subject Hamilton Wetlands Post-Construction As-Built Survey Review – Breach and Completion Contract.

This memorandum presents the ESA's post-construction assessment of the Hamilton Wetland Restoration Project following the Breach and Completion Contract.

FIGURE 1
Post-Construction Surveys

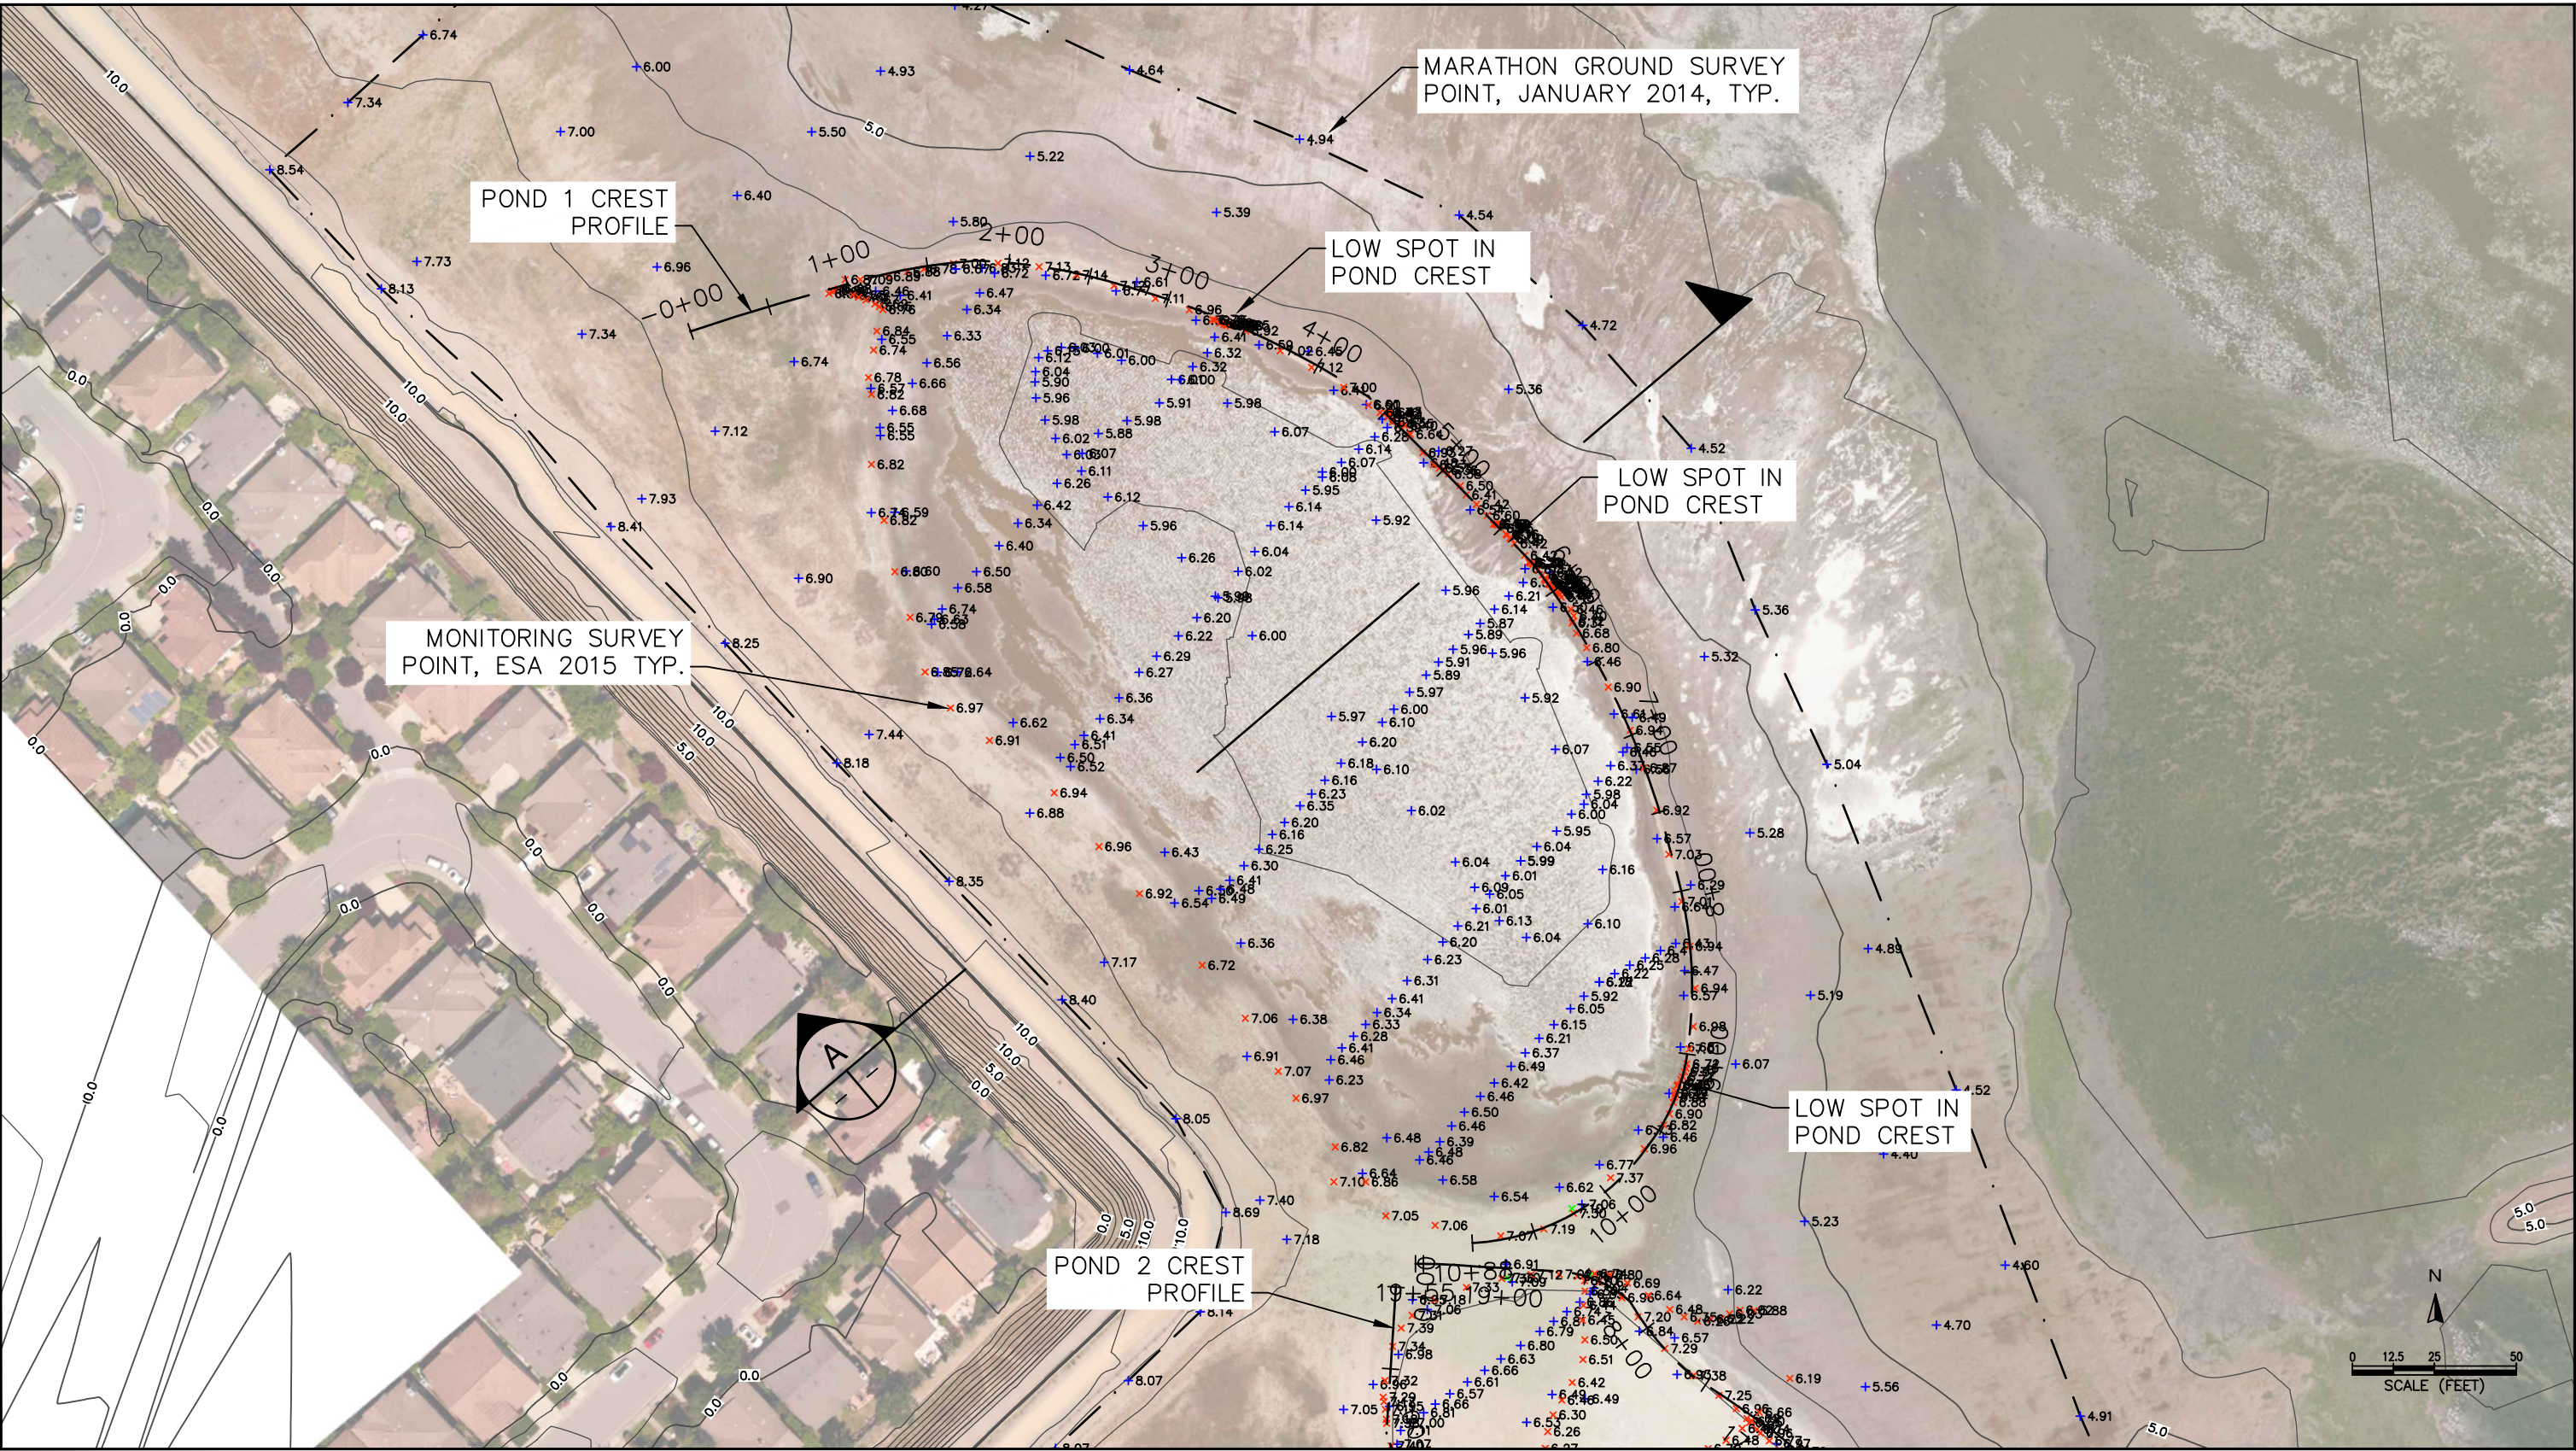
In January 2015 CLE conducted a supplemental hydrographic survey to measure bed elevations in the Expanded Settling Basin and at internal breaches 14, 25 & 26. The extents of this hydrographic survey are shown in Figure 1.

Additional post-construction surveys were conducted by Marathon Construction at the Tidal Panne area and in the South Seasonal Wetlands. Figure 1 shows the locations of the additional post-construction survey points.

Hamilton Post-Construction Assessment . 1764.10
Figure 6
 South Seasonal Wetlands, June 2014
 Post Construction Aerial Photogrammetry
 vs Design Grade

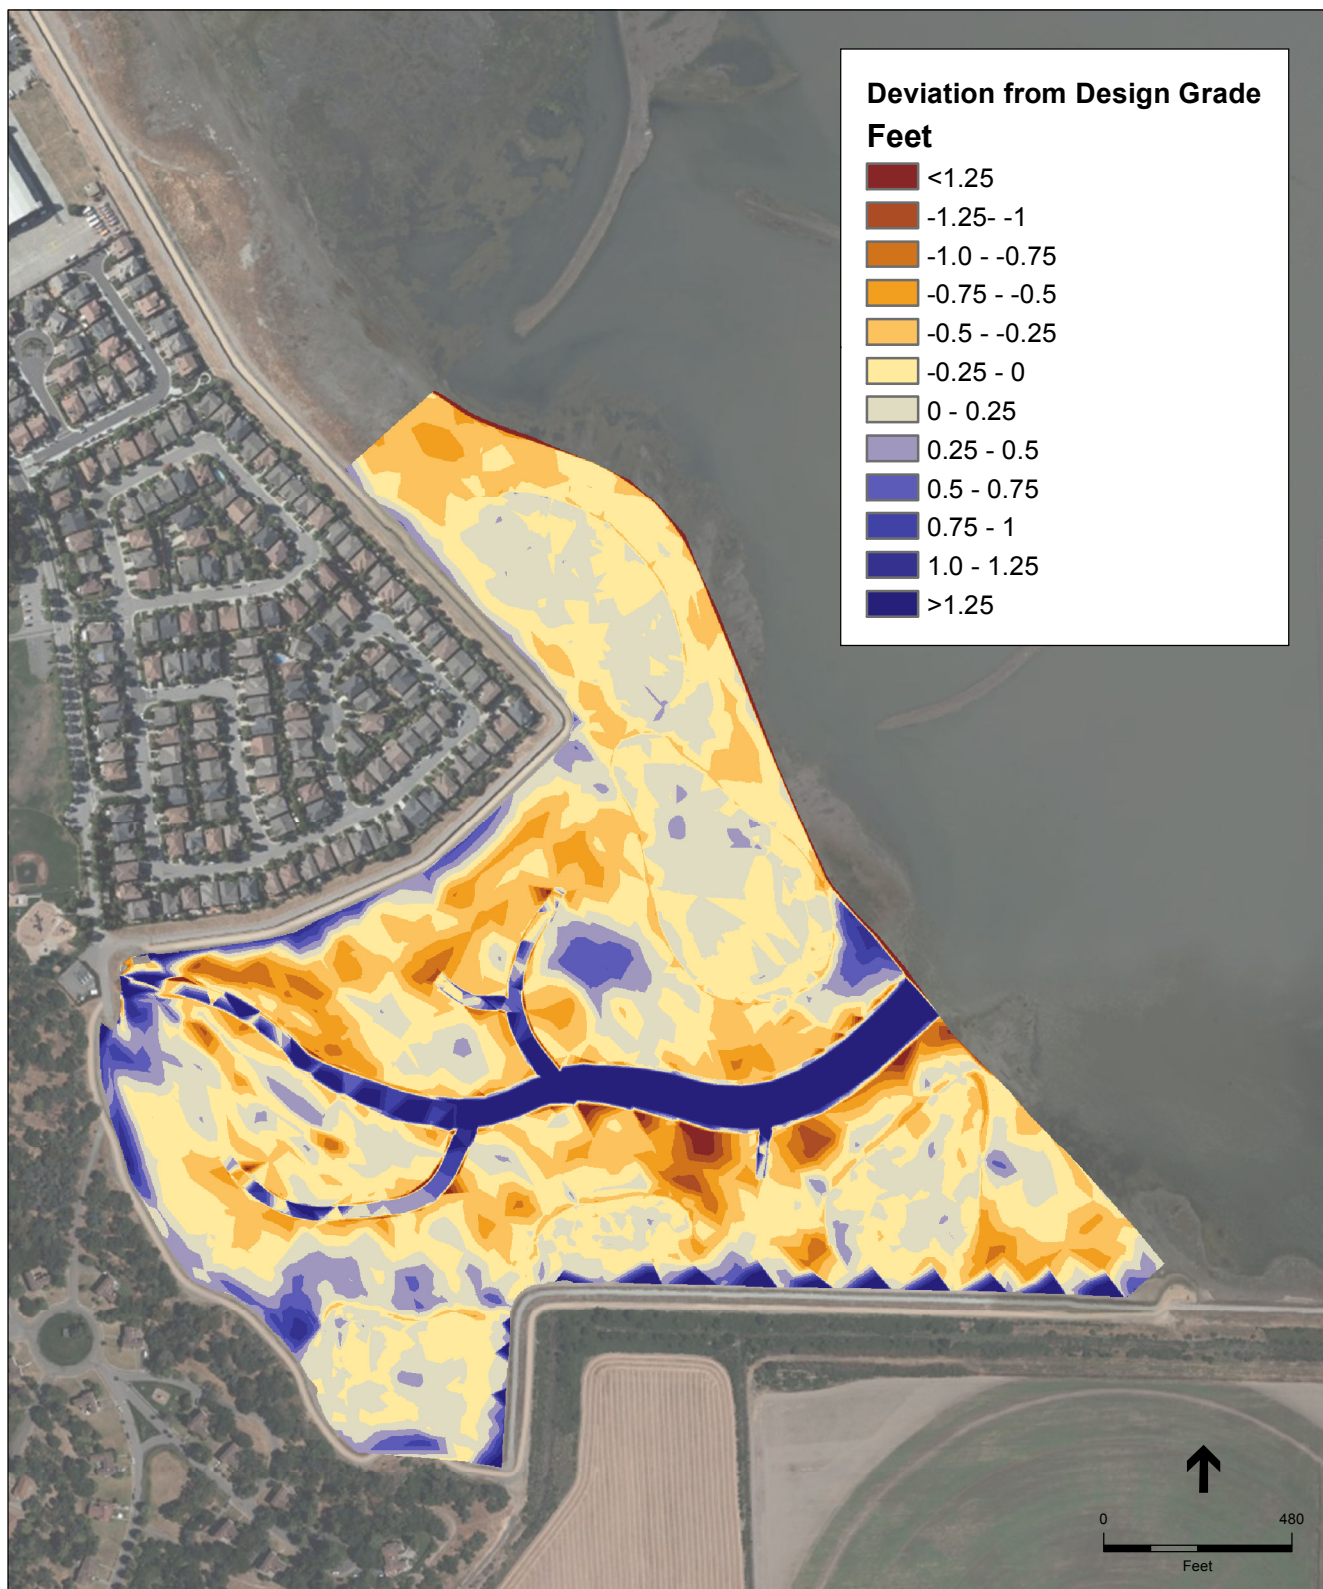
Figures 2 through 5 show the as-built survey data for the various SSW ponds including points collected by Marathon post construction, Aerial photogrammetry, and points surveyed by ESA around the pond crest. Figure 6 shows the difference between the design grade and the post-construction aerial photogrammetry, and Figure 7 shows the difference between the design grade and the post-construction ground survey. Figure 6 highlights significant areas of the SSW marshplain and ponds generally below design grades beyond the design tolerance. Figure 7 shows a smaller extent of out-of-tolerance elevations, but still shows many areas significantly outside of the ± 0.5 ft design tolerance.

South Seasonal Wetlands Cross Sections 1

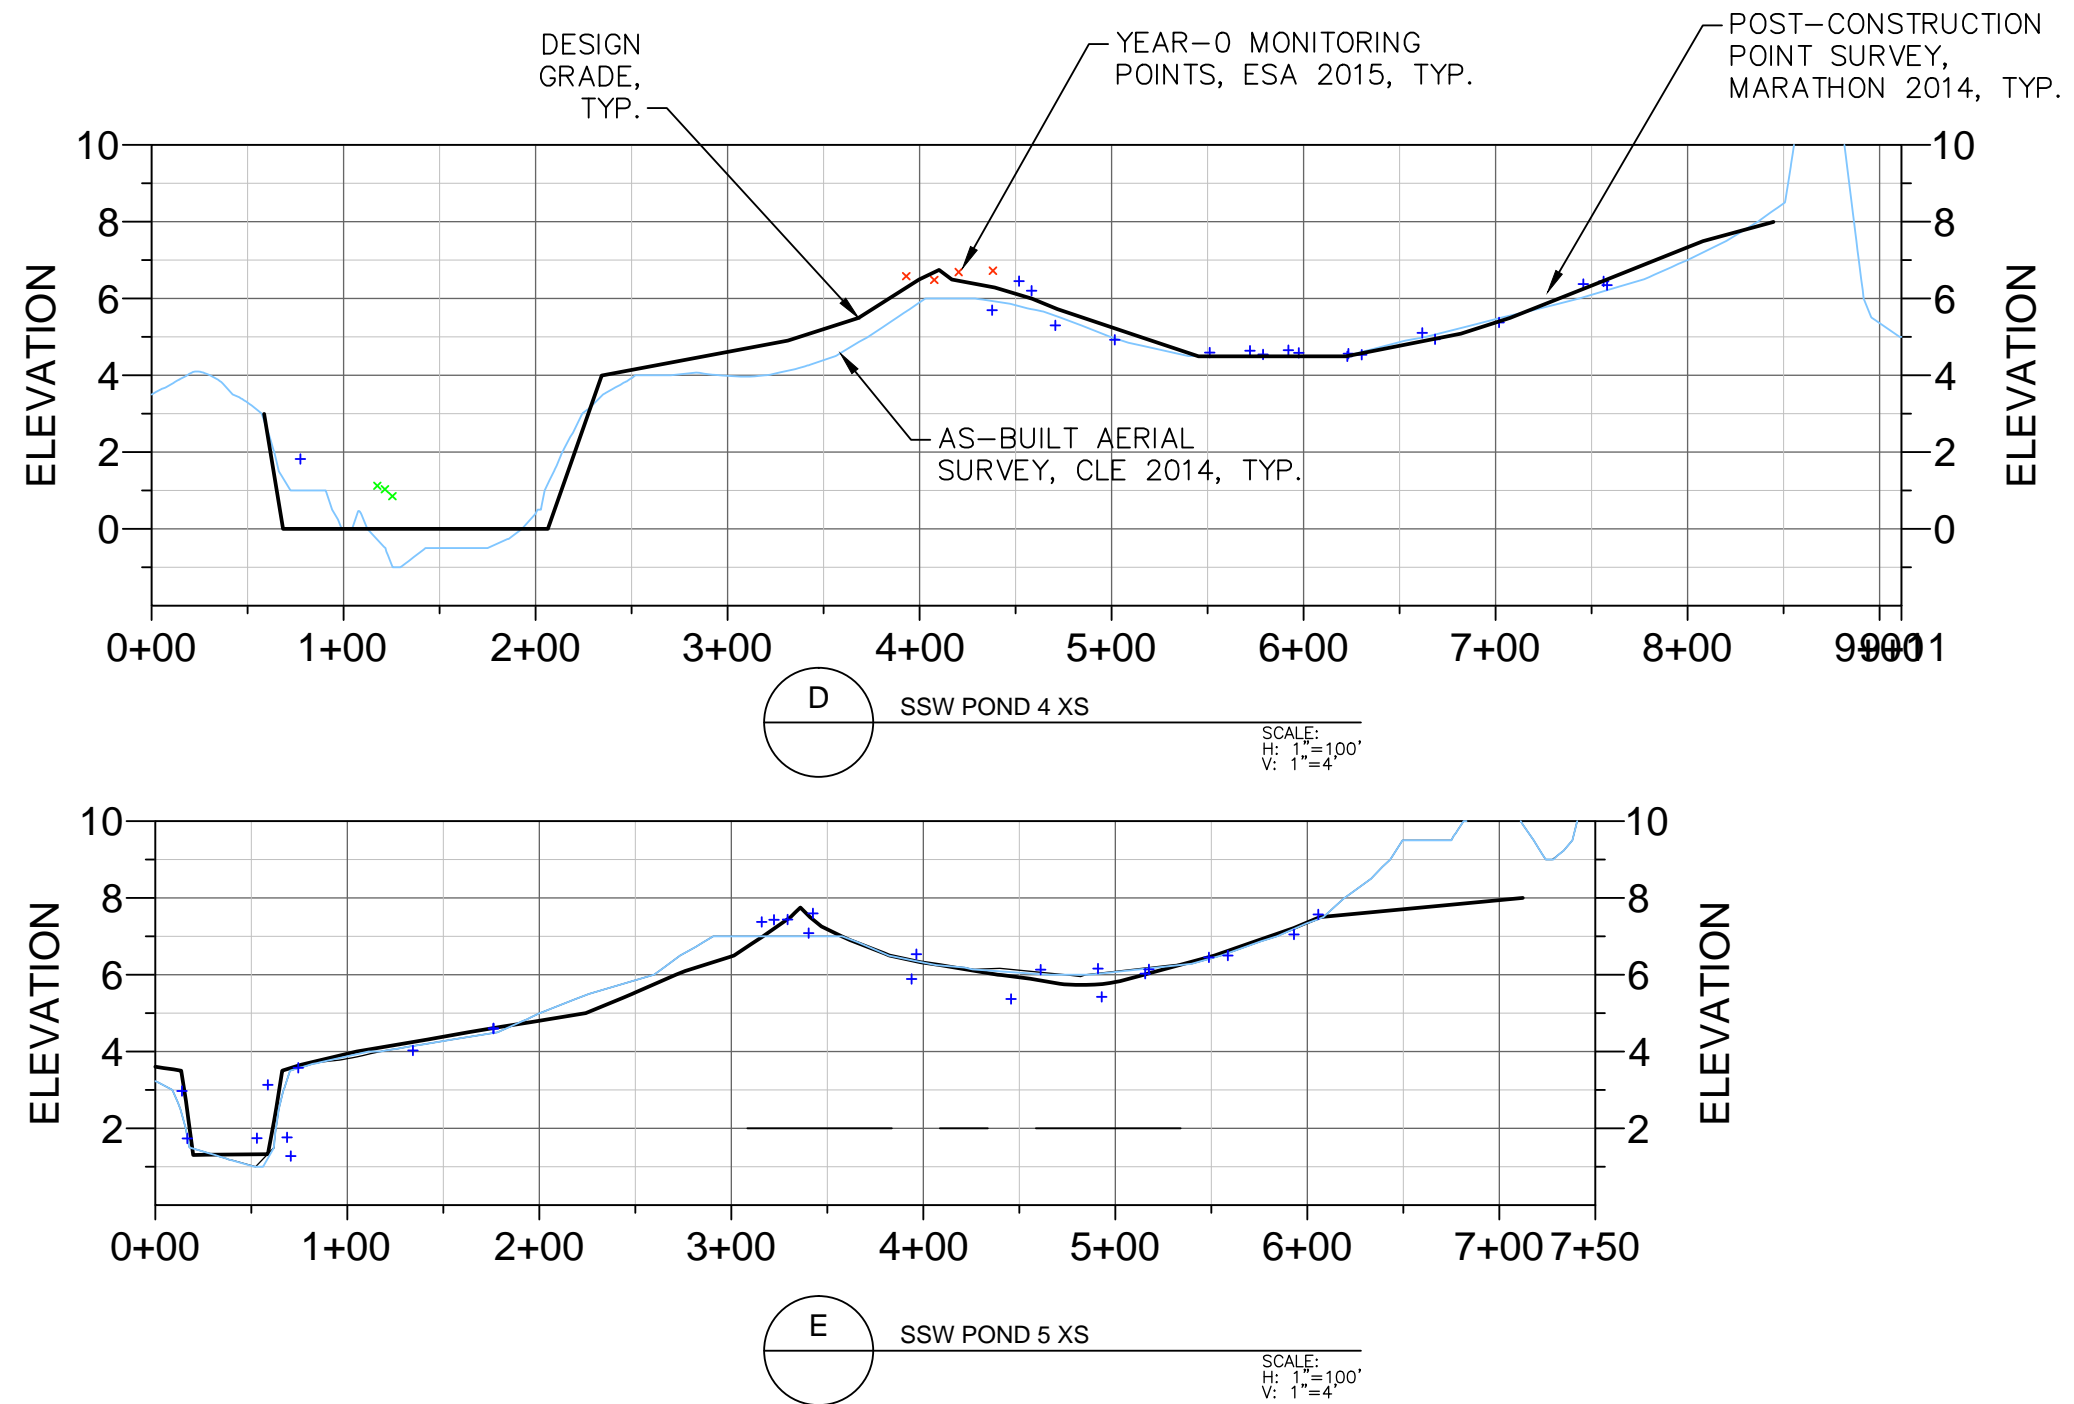
Figures 8 and 9 show cross sections cut through the 5 ponds, and Figures 10 and 11 show profiles taken along the pond crests comparing design and surveyed grades. The post construction aerial photogrammetric survey cross-sections generally plot below design grades, while the post construction point survey (collected soon after completion) are closer to design grades. In general, the as-built pond sill elevations were lower than specified in the design, with portions of all 5 pond crests found to have elevations lower than allowed by the design tolerance. In some locations, erosion has lowered portions of the sill up to 1 foot below design grade as shown in the profiles (ESA 2015 surveys). Crest elevations below design grades subject the ponds to increased tidal exchange and increase drainage during low tides, reducing the habitat value of these areas and increasing the likelihood of erosion. Observations made during the Year-0 monitoring effort note that Pond 1 drains almost completely during low tides due to the emergence of small erosional channels through the pond crest.
